15 Jeanne Court

A correction of dimension to on left side foundation of addition.

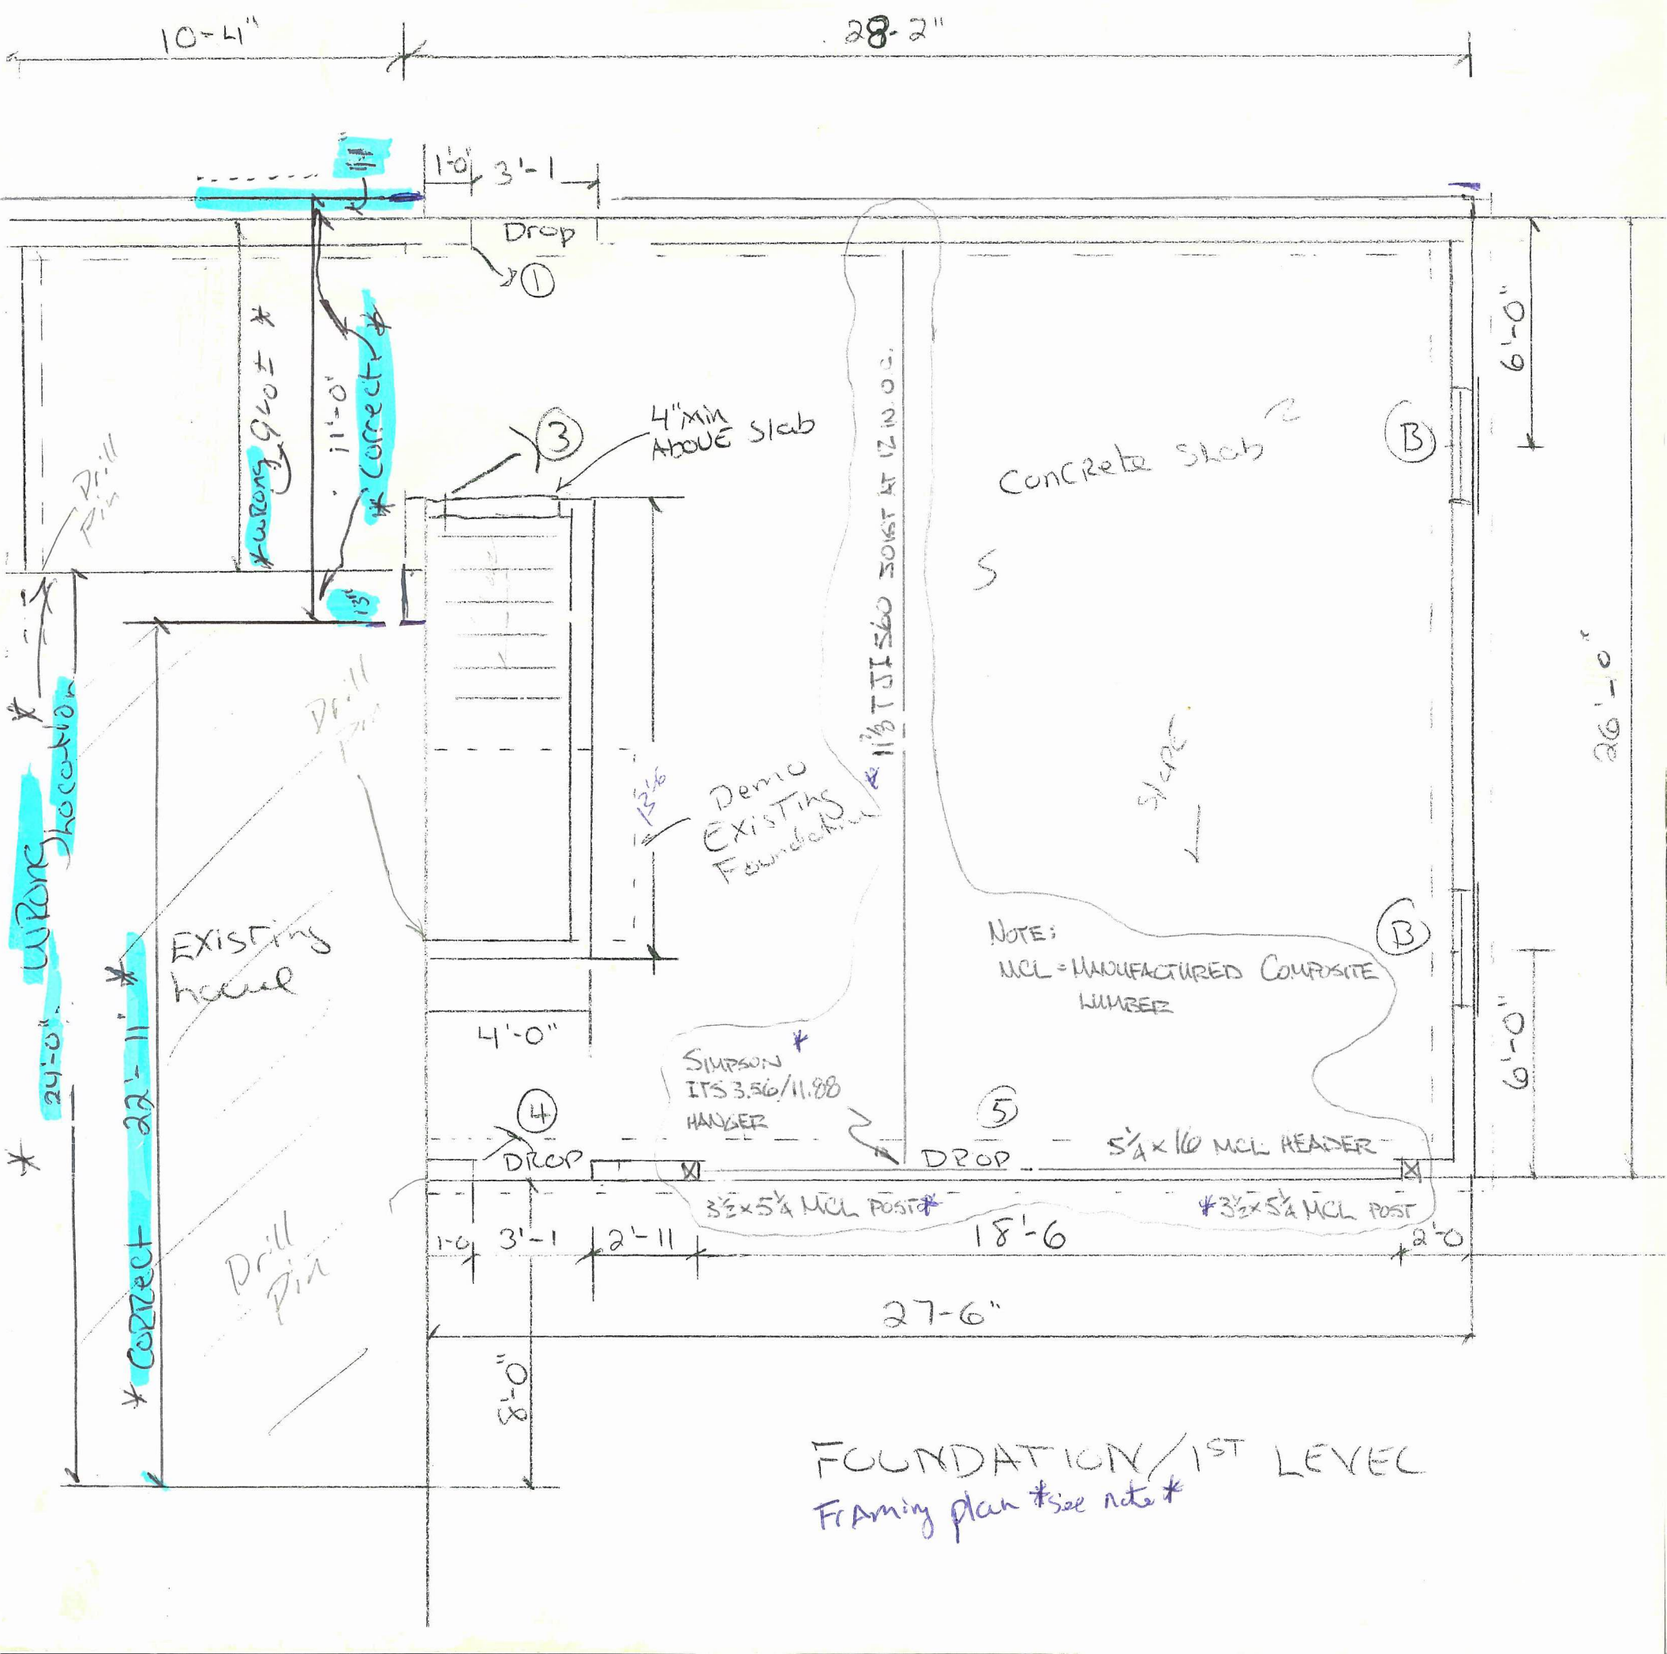
Left side dimension was originally listed as 9' from back of existing house to rear wall of new foundation.

Reason for incorrect dimension.

1) Though the overall dimension for the garage are correct 27'-6 by 26'-0" the rear wall measuring 38'-6". However the rear wall as drawn is 11" off. So when scaled the dimension of the garage actually measure at 25'-2".
2) The existing house foundation as draw is 24'-0" The actual foundation of existing home is 22'-11"

The error in scale of 10"and the error in existing foundation of 13" is what accounts for the dimension error.

BECAUSE ALL SETBACKS WHERE LAYED OUT FROM THE CORRECT LOCATION OF THE FRONT WALL OF THE ADDITION WHERE IT MEETS THE EXISTING FOUNDATION ALL SETBACK ARE CORRECT.

Correct dimension should be 11'.
